# Access Compliance Report

## Public Rights-of-Way

### (Curb Ramps)

Intersection ID: 9957	Main Street: ROSLYN_AV	Cross Street: S_SMALLWOOD_PL	Location: W
ADA ID: F46B38814784	Ramp Type: PerpDiag	Initial Pass/Fail: Fail	Overall Compliance: No
		Severity Score: 10

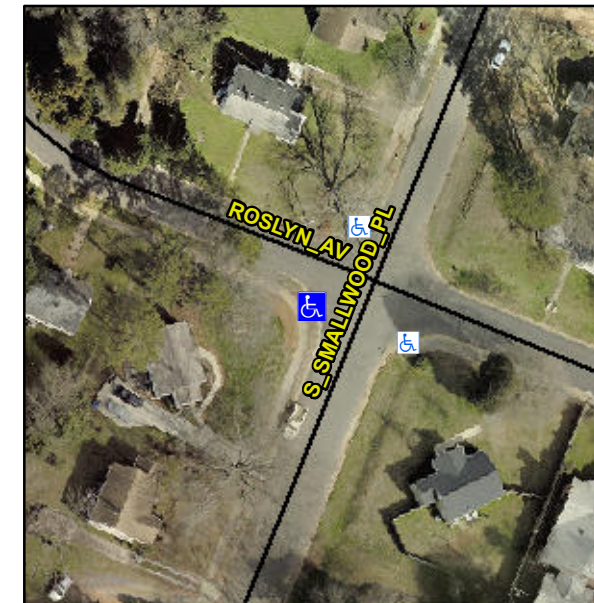
**Not Found, R304.5.1, R304.5.3**

Compliance	Description	Data	Compliance	Description	Data
N/A	Ramp Length (in)	69.5	Yes	Ramp Slope (%)	5.2
No	Ramp Width (in)	47.5	No	Ramp XSlope (%)	4.2
N/A	Flare Type LT	N/A	N/A	Flare Type RT	N/A
N/A	Flare Slope LT (%)	N/A	N/A	Flare Slope RT (%)	N/A
N/A	Flare Traversable LT?	N/A	N/A	Flare Traversable RT?	N/A
N/A	Landing Length (in)	N/A	N/A	DWS Provided?	N/A
N/A	Landing Width (in)	N/A	N/A	DWS Contrast?	N/A
N/A	Landing Slope (%)	N/A	N/A	DWS Length (in)	N/A
N/A	Landing X Slope (%)	N/A	N/A	DWS Full Width?	N/A
N/A	Landing Curb? (Y/N)	N/A	N/A	DWS Offset (in)	N/A
N/A	Shared Landing?	N/A			
N/A	Gutter Ponding?	N/A	N/A	Gutter Slope (%)	N/A
N/A	Gutter Lip Ht (in)	0.5	N/A	Gutter X Slope (%)	N/A
N/A	Painted X Walk1?	No	N/A	Painted X Walk2?	No
	X Walk 1 Direction	To SE		X Walk 2 Direction	To NE
N/A	X Walk 1 Width (in)	N/A	N/A	X Walk 2 Width (in)	N/A
	X Walk 1 Slope (%)	8.4		X Walk 2 Slope (%)	3.8
	X Walk 1 X Slope (%)	2.1		X Walk 2 X Slope (%)	6.0

**Remove & Replace Curb Ramp With Two New Directional Ramps or Equivalent.**
